## New spare parts for Thermomixer Comfort 5355 and Compact 5350

Both devices have been modified.

Fig 1 Motor "old version" 5350 005.155

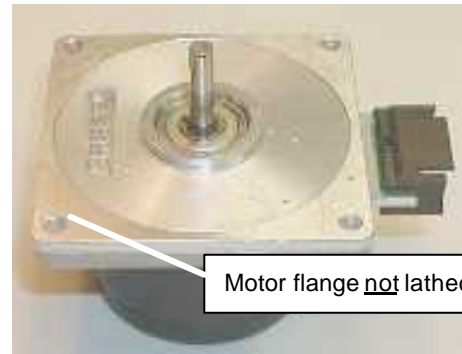
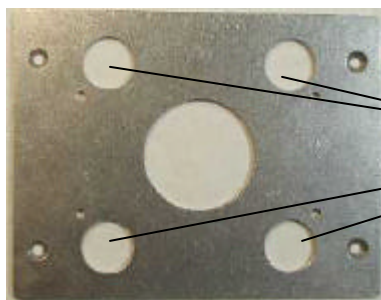
The flange of the old motor was lathed (see Fig 1). As a result, the position of the screw heads that hold the motor was deeper. The flange of the new motor has not been lathed (see Fig 2). Instead, the base plate of the new Oscillating Frame System (OFS) has additional holes to make room for the higher standing screw heads. (See Fig 3). However, the „new“ OFS can also be operated with the old motor.

Lathed motor flange

Motor flange not lathed

Fig 2 Motor "new version" 5350 866.002
